1. a) Consideration of Ordinance #968 approving a Final Subdivision request for Riverside Flats Subdivision, located at approximately 671 West and 633 West 4400 South, Riverdale, Utah 84405, as requested by Wright Development Group.

b) Consideration of Final Site Plan request for Riverside Flats Apartments, located at approximately 671 West 4400 South, Riverdale, Utah 84405, as requested by Wright Development Group.

## Final Subdivision/Site Plan Review – WDG Subdivision and Riverdale Apartments Site Plan – 671 & 633 West 4400 South

### **Plan Review For Riverside Flats**

**C600**

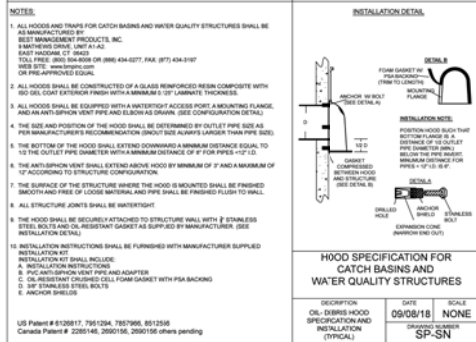
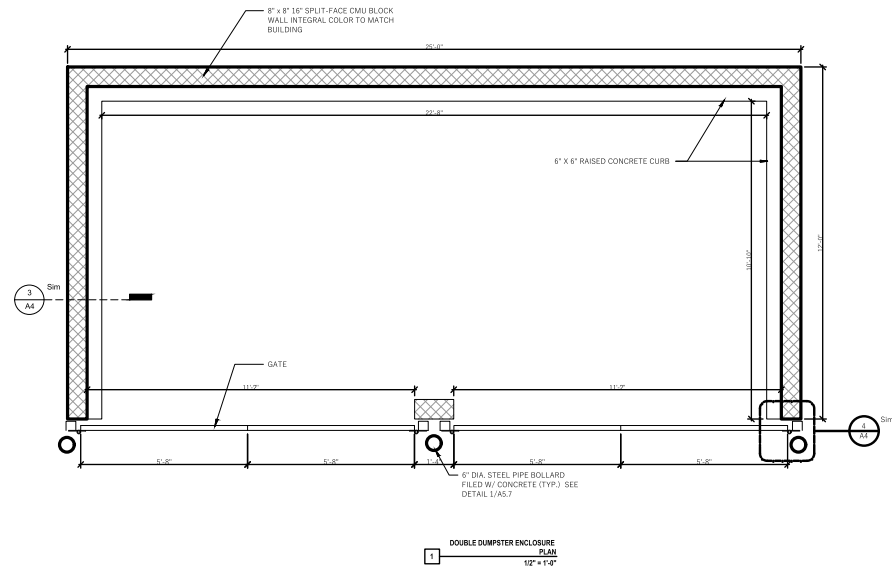
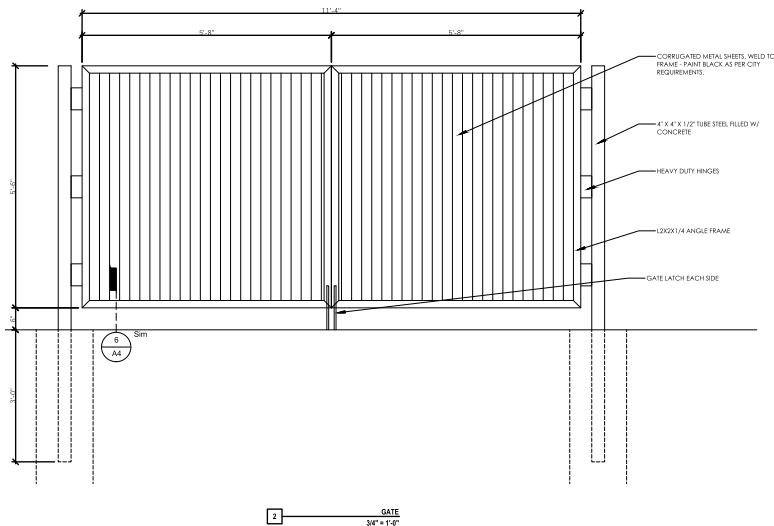
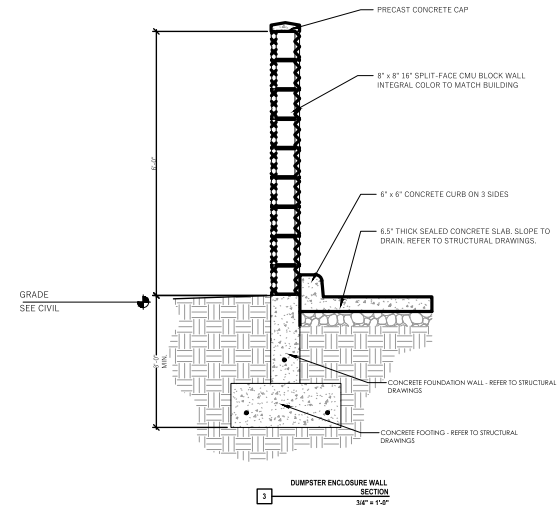
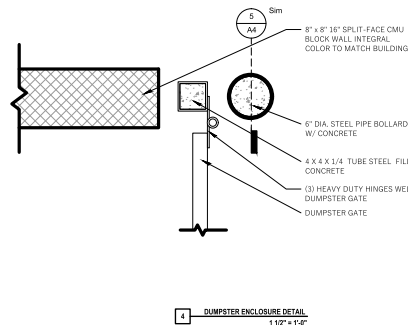
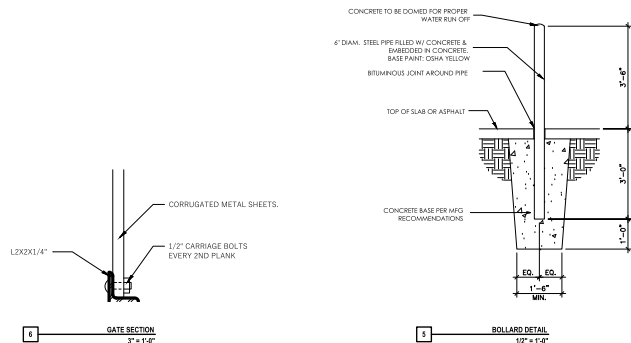
1. Slab in dumpster enclosure should be thick enough to withstand the weight of the full dumpster and trash truck while emptying dumpster. Suggest 6" thick slab or rebar reinforcement.	Response: Refer to detail C5 on Sheet C600. This meets/exceeds these requirements.

**Response:** Refer to detail C5 on Sheet C600. This meets/exceeds these requirements.

## Storm Water Pollution Prevention Plan

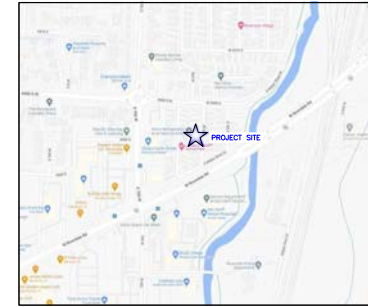
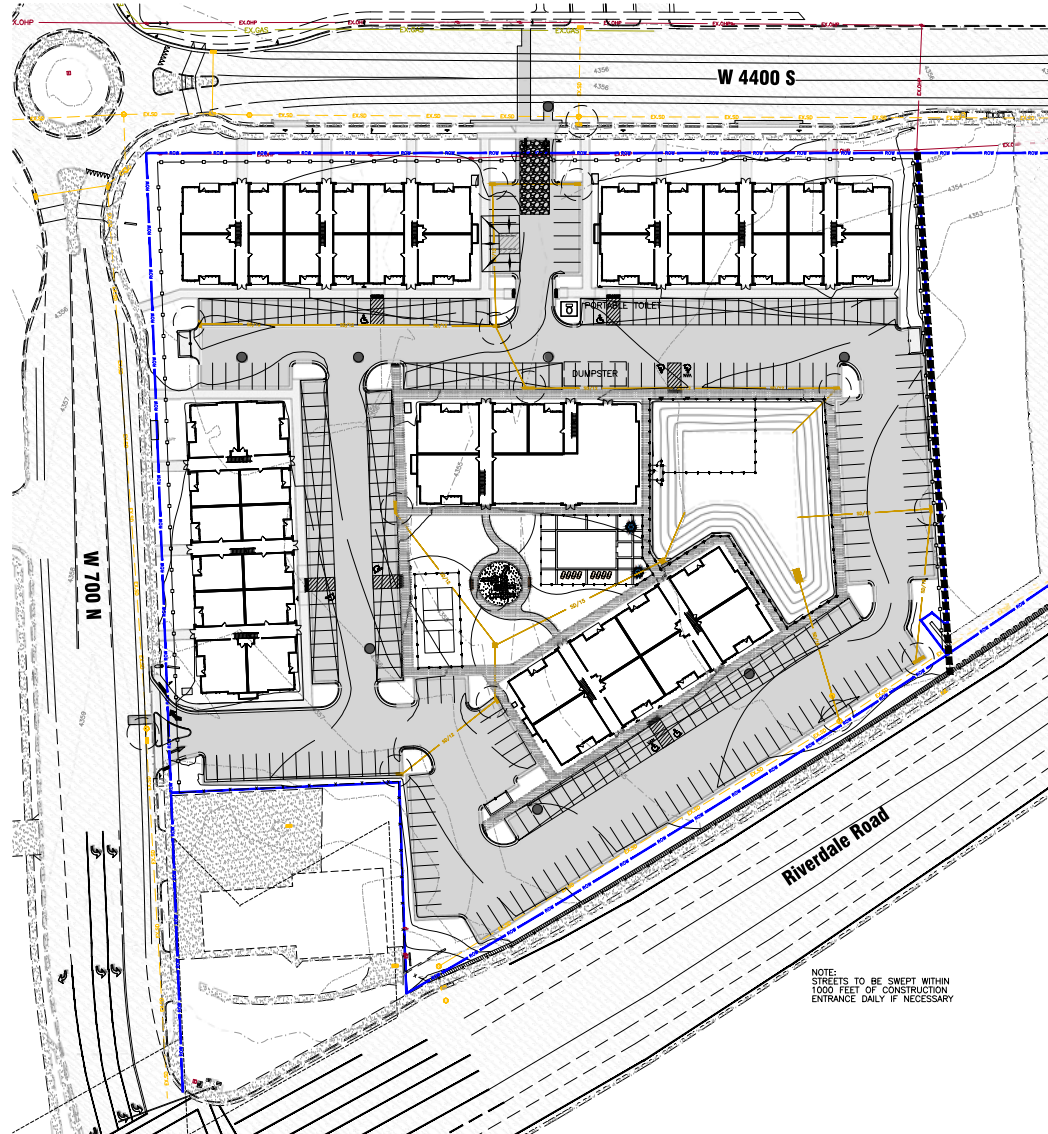
9. Storm water protection plan issues: Vicinity my shown on the SWPPP is incorrect.	Corrected.
